MPC860/855T Family Device Errata Reference

This document is a compilation of all MPC855T, MPC860, MPC860SAR, and MPC860T device errata from Revision A.2 forward. Herein, the errata are classified and numbered, and each erratum is provided with a description and workarounds in the second part of the document. To determine which silicon revision and mask set are associated with which version, please refer to [Table 2](#). To find which errata apply to a particular device, please refer to the errata listings for each revision provided in [Table 4](#). Indications of schedules for errata fixes are provided in the errata listing of the latest revision of each part.

Figure 1. Workaround for Case 2

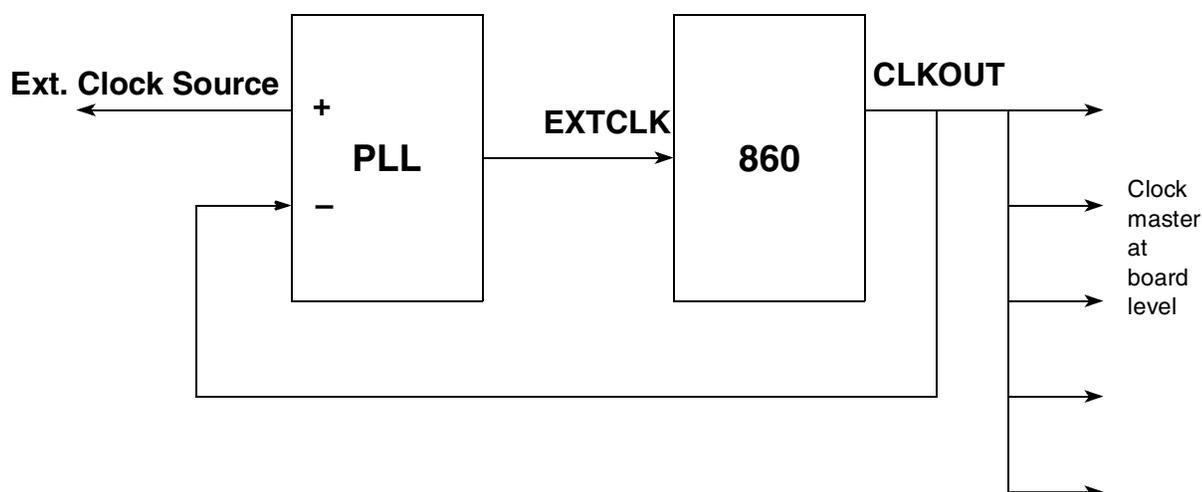
G4 Potential problems caused by skew between EXTCLK and CLKOUT

Description:

In correct operation, the PLL of the MPC860 will lock on the rising edge of the input clock. However, on these revisions of the MPC860, the PLL locks on the falling edge of the input clock. This affects the skew between EXTCLK and CLKOUT at the rising edge. The skew is dependent on the duty cycle of the input clock (but for a 50% duty cycle will not exceed 2nS). This affects synchronous designs where the same clock source is used as an input to EXTCLK, as well as to an external synchronous device (for example, a peripheral or ASIC).

Case 2. It is necessary to synchronize an external master clock (for example, from a backplane), an MPC860, and external peripherals, to allow data transfer in all three directions.

Insert a PLL between the external master clock and the EXTCLK pin of the MPC860. Connect the phase comparison pin of the PLL to the CLKOUT pin of the MPC 860. Also use the CLKOUT signal as the reference clock for distribution to the local external peripherals.

The PLL must be capable of operating with a permanent offset of -2nS, therefore the range of lock should extend to about -4nS.
